**HADITHA GENERAL HOSPITAL**  
**UNDER THE ECONOMIC SUPPORT FUND PROGRAM**  
**HADITHA, IRAQ**

**SIGIR PA-08-132**  
**JANUARY 23, 2009**

SUBJECT: Report on Project Assessment of the Haditha General Hospital, Haditha, Iraq  
(SIGIR Report Number PA-08-132)

**Figure 3. Preliminary floor plan of the new surgery wing addition**

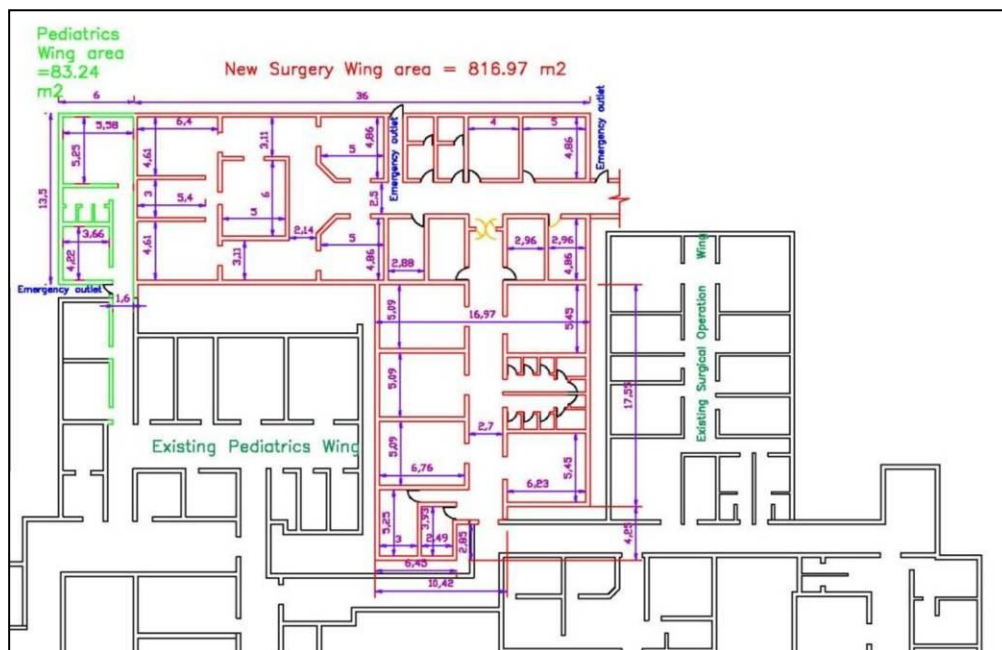
On 29 May 2008, the contractor submitted the revised proposal for the renovation and additions to the Haditha General Hospital project. The contractor included several preliminary floor plans for the proposed additions (Figures 3 and 4). The contract's BOQ provided enough information and detail for the contractor to renovate the hospital without detailed designs.

At the time of SIGIR's site visit, the contractor had not provided the USACE GRC with the design drawings for the revised SOW. According to USACE GRC representatives, the submittals were more than a month behind schedule and were not expected for at least another two weeks.
